PERRY TOWNSHIP, FRANKLIN COUNTY, OHIO  
**SANITARY SEWER IMPROVEMENT PLAN**  
**THE COTTAGES AT BROOKSIDE**  
**FOR**  
**BG & CC DEVELOPMENT COMPANY LLC**  
 SANITARY TRIBUTARY MAP

CITY OF COLUMBUS DEPARTMENT OF PUBLIC UTILITIES APPROVED TIFF IMAGE FOR REVISION

Drawing Number:  
**7A / 8**

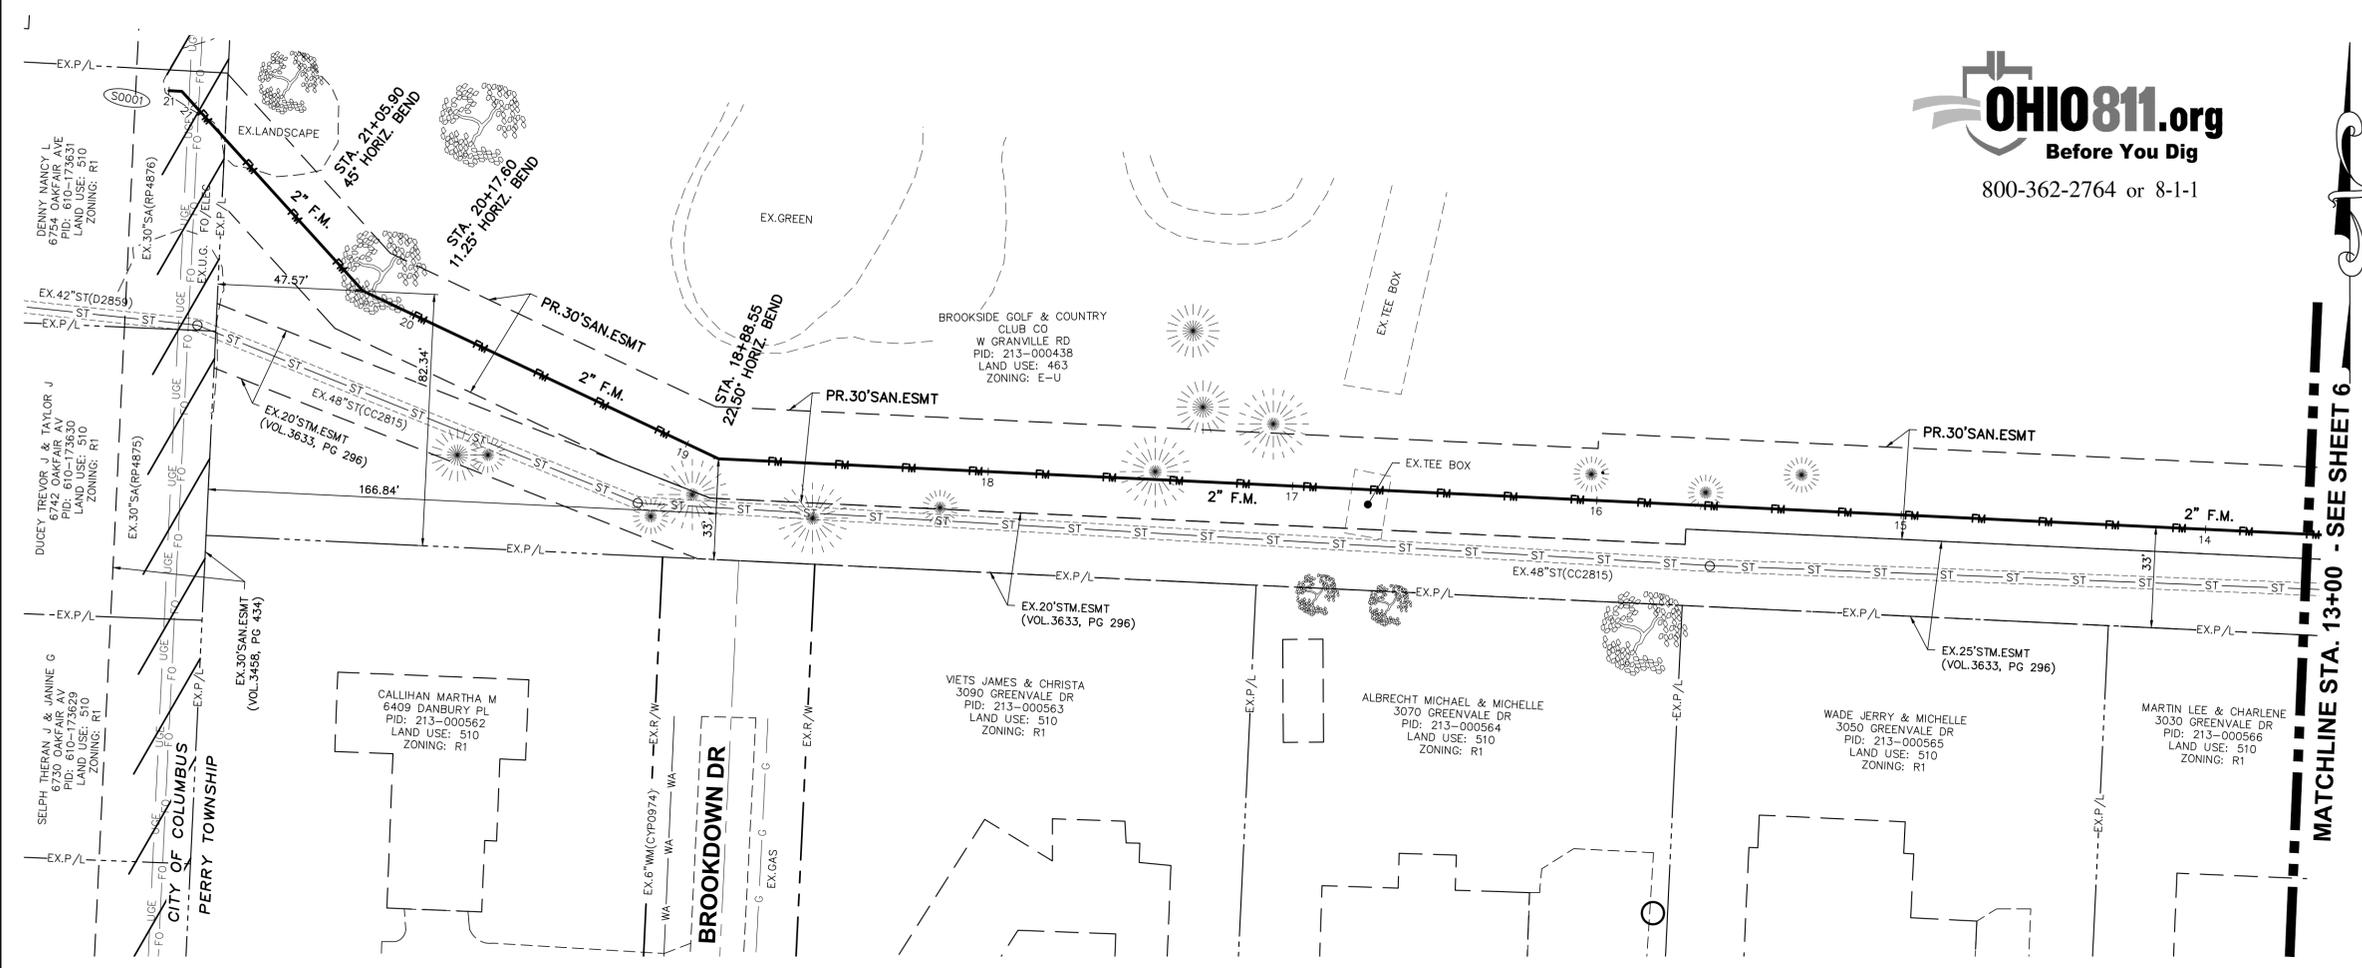
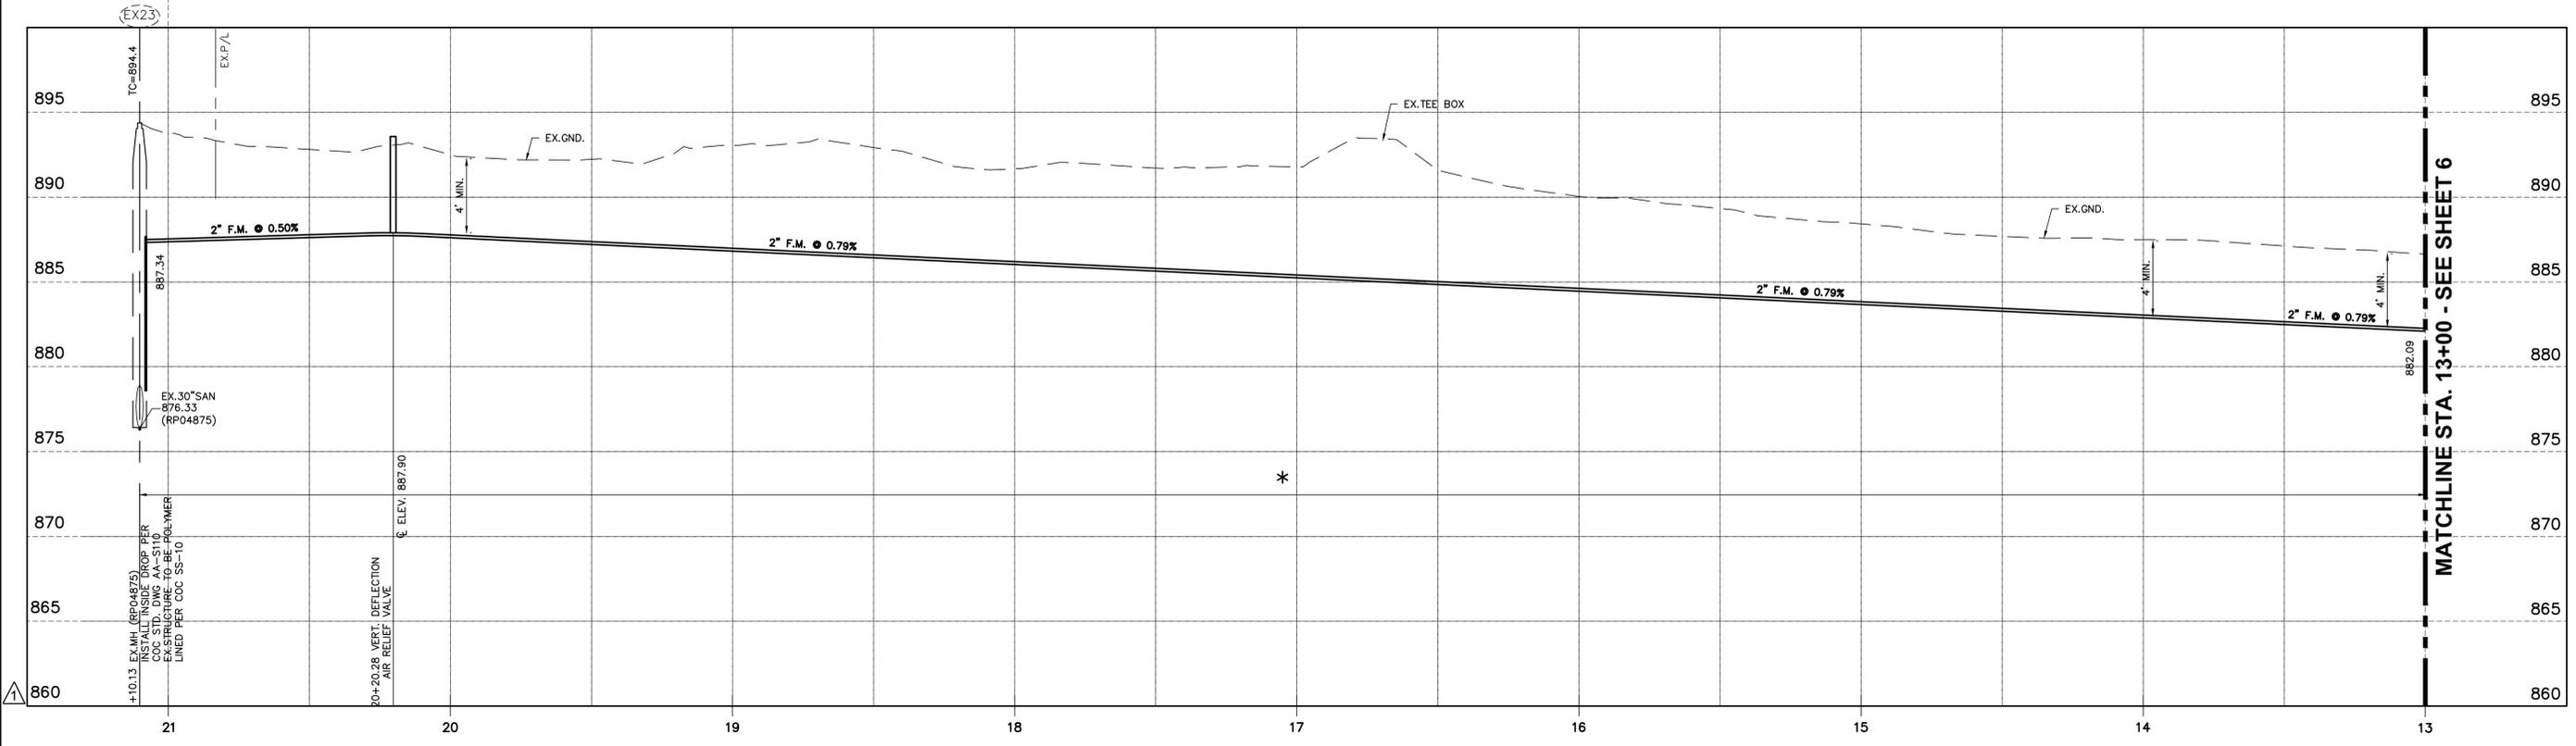
No.	Revision	Date	Approved
1	REVISED FORCE MAIN PROFILE DESIGN
